Service Notification	
	Flight Design GmbH Sielminger Str. 51 D-70771 L.-Echterdingen Tel.: +49(0)7021 80460-0 Fax: +49(0)7021 80460-69 E-Mail: airworthiness@flightdesign.com	SN-LTUL-CTLS-02 Revision 00
	Date of Initial Publication: 28-Mar-2011 Publication Date of this Revision: 28-Mar-2011

Service Notification

Elimination of Noise in Radio from Dynon SkyView SV-D1000 SN-LTUL-CTLS-02

Fig. 3

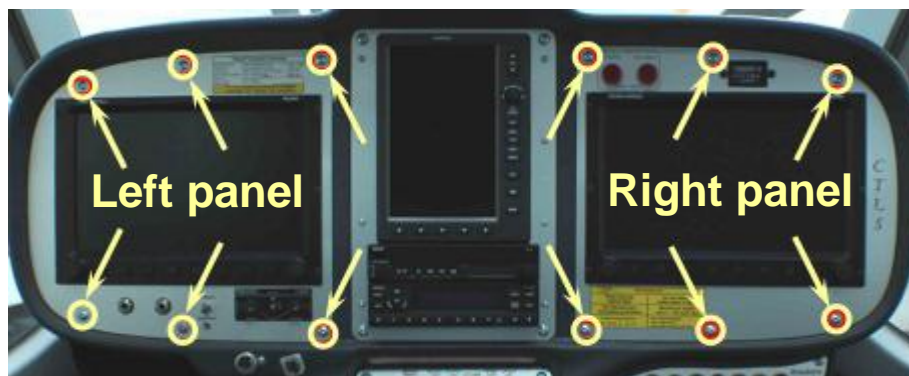
1. Unscrew 6 screws of the left panel, shown on Fig. 3, using 3 mm Allen key. Remove the left panel of the instrument console.

5. Install the left panel of the instrument console by screwing the 6 screws of the left panel, shown on Fig. 3, using 3 mm Allen key.
